**Economic Commission for Europe****Inland Transport Committee****World Forum for Harmonization of Vehicle Regulations****Working Party on Lighting and Light-Signalling****Ninety-first session**

**Device UN Regulations:****UN Regulation No. 148 (Light-Signalling Devices)****Proposal for a Supplement to the 01 series of amendments to UN Regulation No. 148 and to the 06, 07, 08 and 09 series of amendments to UN Regulation No. 48****Submitted by the expert from the International Automotive Lighting and Light-Signalling Expert Group\***

The text reproduced below was prepared by the expert from the International Automotive Lighting and Light-Signalling Expert Group (GTB) with the aim to introduce Direction Indicator Projections. The proposal is based on informal document GRE-90-16. The modifications to the existing text of the UN Regulation are marked in bold for new or strikethrough for deleted characters.

**6.27.5.2. Rear direction indicator projection**

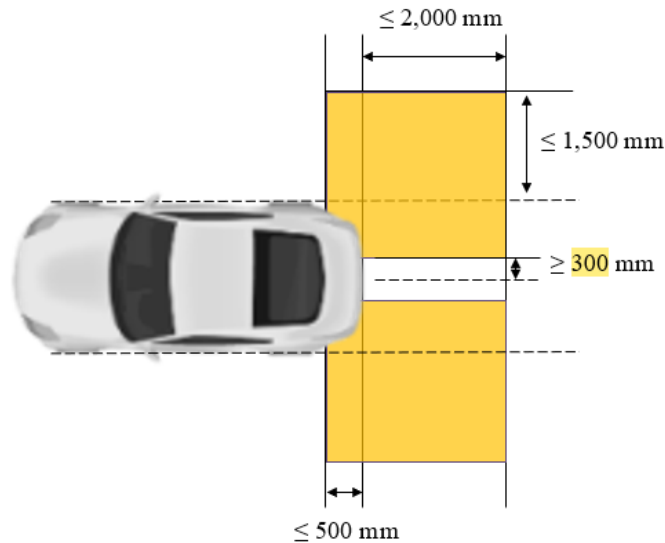
The lateral distance from the outer edge of the projection with respect to the extreme outer edge of the vehicle shall not be more than 1,500 mm.

The longitudinal distance from the rearmost edge of the projection shall not be more than 2,000 mm from the rearward extreme outer edge of the vehicle and the forward edge of the projection shall be not more than 500mm forward of the rearward extreme outer edge of the vehicle.

The inner boundary of the projection area is limited by a minimum distance of 300 mm from the longitudinal centre line of the vehicle (see figure below).

**6.27.5.3. Side direction indicator projection**

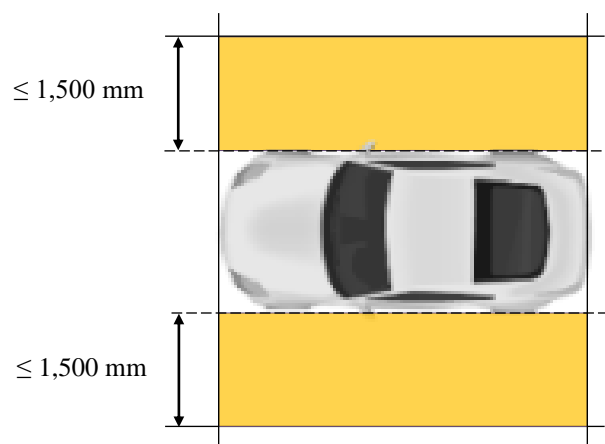
The lateral distance from the outer edge of the projection with respect to the extreme outer edge of the vehicle shall not be more than 1,500 mm.

In length, the projection area is limited by the vehicle length (see figure below)

**6.27.5.4.** The patterns of each front direction indicator projection shall start with their closest edge within a zone limited by:

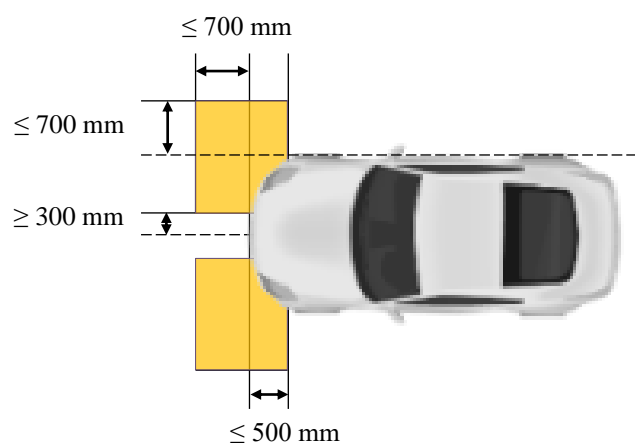
- a transverse plane 700 mm forwards of the front outer edge of the vehicle,
- a transverse plane 500 mm rearwards of the front outer edge of the vehicle,
- a longitudinal plane 700 mm outwards from the extreme outer edge of the vehicle and
- a longitudinal plane 300 mm outwards from the longitudinal median plane of the vehicle (see figure below)

**6.27.5.5.** The patterns of each rear direction indicator projection shall start with their closest edge within a zone limited by:

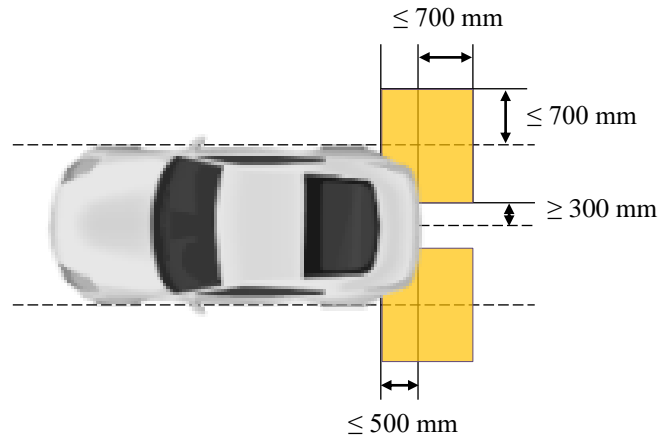
- a transverse plane 700 mm rearwards of the rear outer edge of the vehicle,
- a transverse plane 500 mm forwards of the rear outer edge of the vehicle,
- a longitudinal plane 700 mm outwards from the extreme outer edge of the vehicle and
- a longitudinal plane 300 mm outwards from the longitudinal median plane of the vehicle (see figure below).

**6.27.5.6.** The patterns of each side direction indicator projection shall start with their closest edge within a zone limited by:

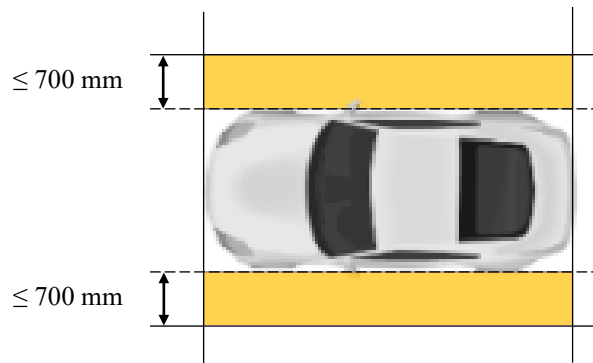
- a transverse plane at the front outer edge of the vehicle,
- a transverse plane at the rear outer edge of the vehicle and
- a longitudinal plane 700 mm outwards from the extreme outer edge (see figure below)

**6.28.5.2. Rear direction indicator projection**

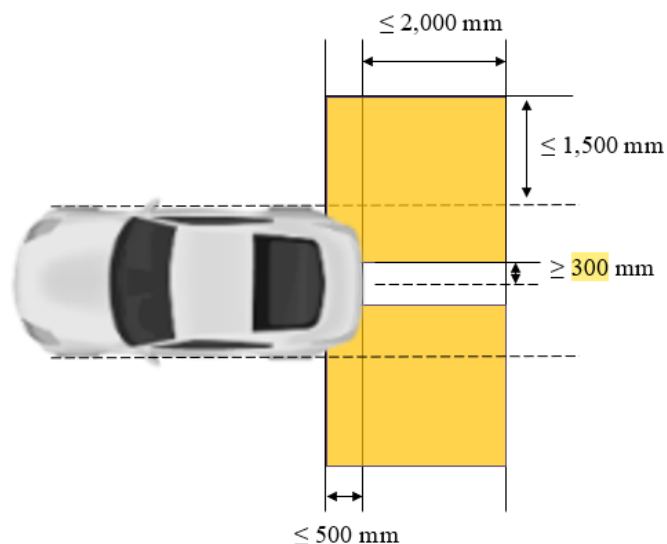
The lateral distance from the outer edge of the projection with respect to the extreme outer edge of the vehicle shall not be more than 1,500 mm.

The longitudinal distance from the rearmost edge of the projection shall not be more than 2,000 mm from the rearward extreme outer edge of the vehicle and the forward edge of the projection shall be not more than 500 mm forward of the rearward extreme outer edge of the vehicle.

The inner boundary of the projection area is limited by a minimum distance of 300 mm from the longitudinal centre line of the vehicle (see figure below).

### 6.28.5.3. Side direction indicator projection

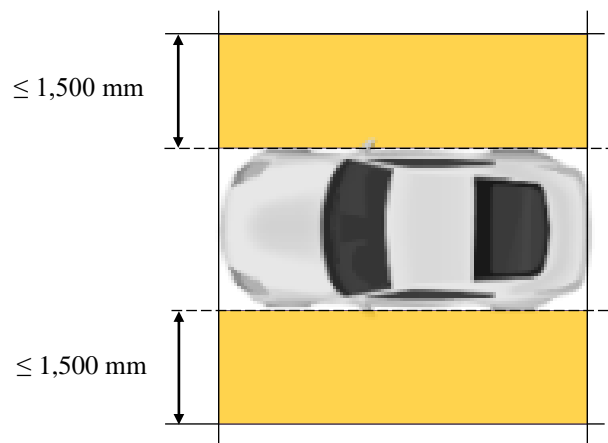
The lateral distance from the outer edge of the projection with respect to the extreme outer edge of the vehicle shall not be more than 1,500 mm.

In length, the projection area is limited by the vehicle length (see figure below).

### 6.28.5.4. The patterns of each front direction indicator projection shall start with their closest edge within a zone limited by:

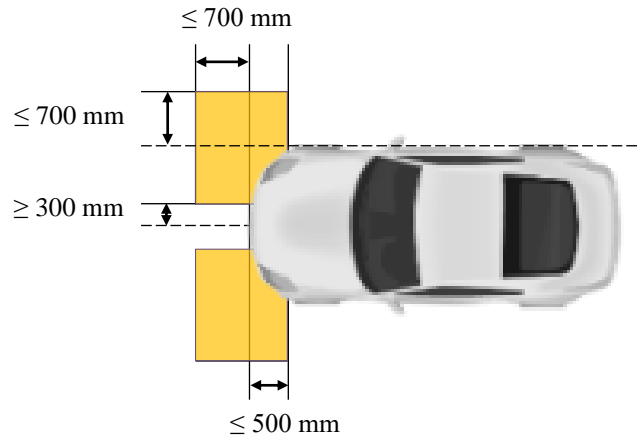
- a transverse plane 700 mm forwards of the front outer edge of the vehicle,
- a transverse plane 500 mm rearwards of the front outer edge of the vehicle,
- a longitudinal plane 700 mm outwards from the extreme outer edge of the vehicle and
- a longitudinal plane 300 mm outwards from the longitudinal median plane of the vehicle (see figure below).

**6.28.5.5.** The patterns of each rear direction indicator projection shall start with their closest edge within a zone limited by:

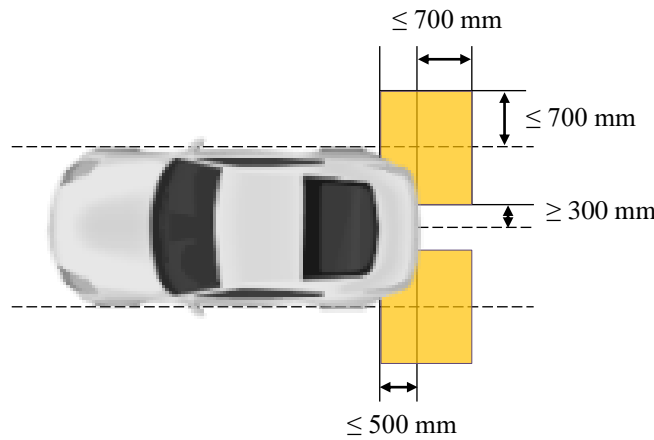
- a transverse plane 700 mm rearwards of the rear outer edge of the vehicle,
- a transverse plane 500 mm forwards of the rear outer edge of the vehicle,
- a longitudinal plane 700 mm outwards from the extreme outer edge of the vehicle and
- a longitudinal plane 300 mm outwards from the longitudinal median plane of the vehicle (see figure below).

**6.28.5.6.** The patterns of each side direction indicator projection shall start with their closest edge within a zone limited by:

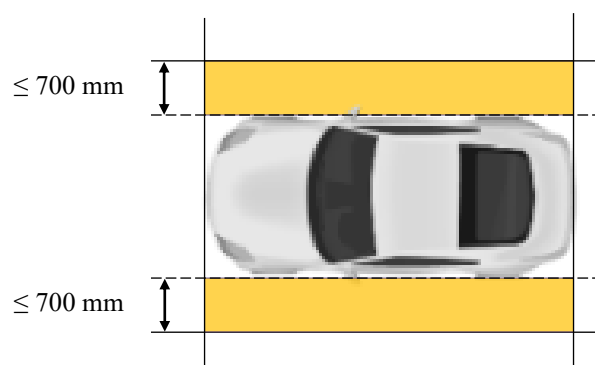
- a transverse plane at the front outer edge of the vehicle,
- a transverse plane at the rear outer edge of the vehicle and
- a longitudinal plane 700 mm outwards from the extreme outer edge (see figure below).
